TLE984xQX

Microcontroller with LIN and Power Switches for Automotive Applications

Reference: Data Sheet Rev. 1.0

This document lists the deviations of the TLE984xQX “Microcontroller with LIN and Power Switches for Automotive Applications” from the Data Sheet, Rev. 1.0.

Figure 1 lowside clamping, normal case ($V_s = 13.5V$, relay, 160 Ohm (nom.))

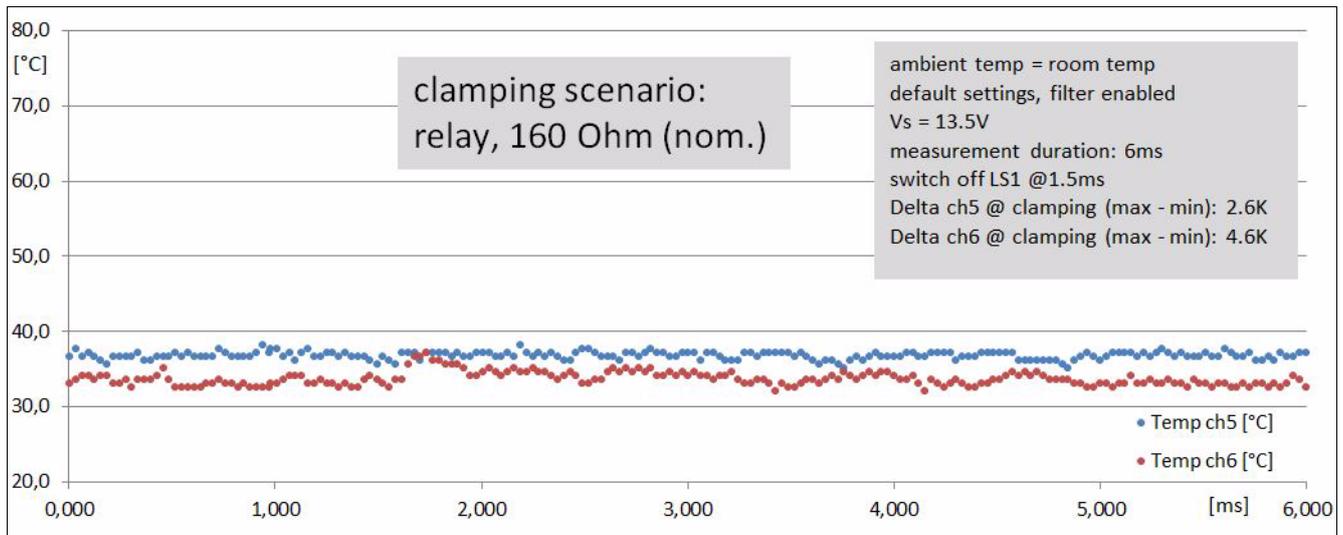
Figure 1 shows the temperature effect of LS1 clamping in normal operating condition. The local heating effect caused by the clamping of the lowside can be seen in channel 6 instead of the expected channel 5, as the channels appear swapped. The short temperature increase caused by the clamping is <5Kelvin.

Figure 2 lowside clamping, worst case (V_s maximized to reach 2mJ clamping energy, relay, 160 Ohm (nom.))

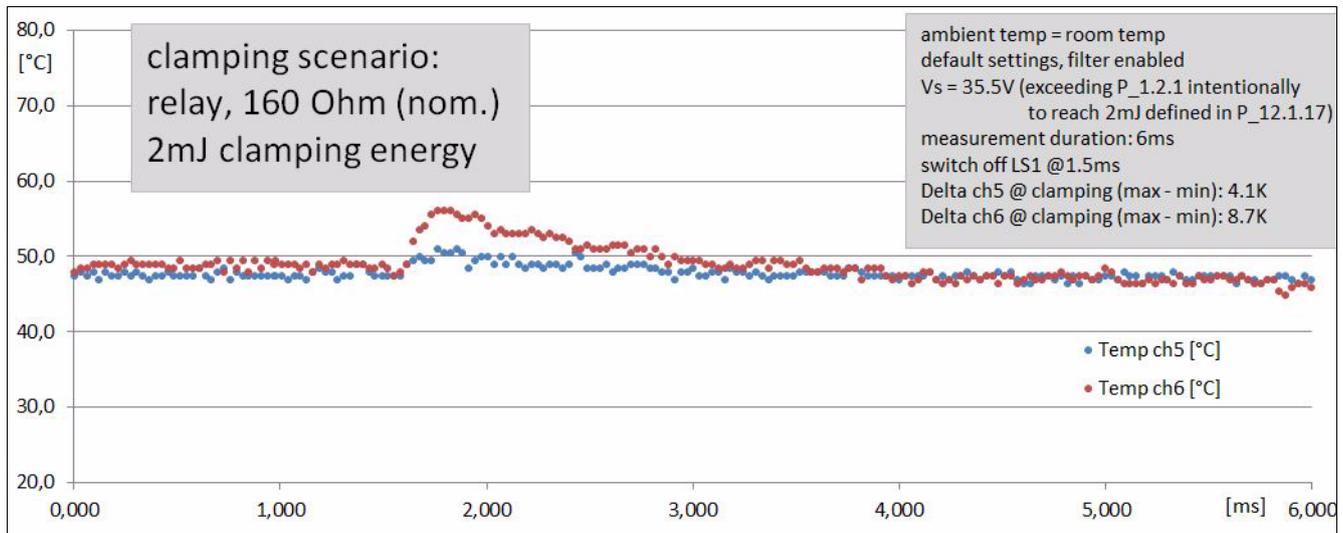
Figure 2 shows the temperature effect of LS1 clamping at worst case conditions. V_s has been selected intentionally that high to reach 2mJ clamping energy as specified in P_12.1.17. Again, the short temperature increase can be seen in channel 6 instead of channel 5, and is <9Kelvin.

Figure 3 lowside current, normal case ($V_s = 13.5V$, relay, 160 Ohm (nom.))

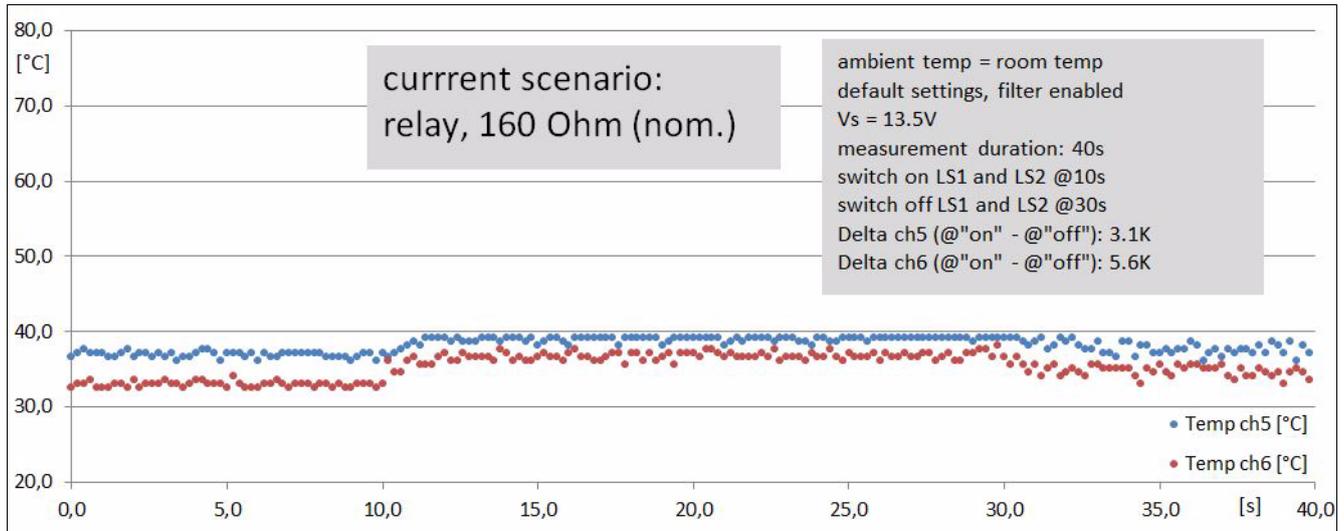
Figure 3 shows the temperature effect of a relay current in normal operating condition. The local heating is <6Kelvin.
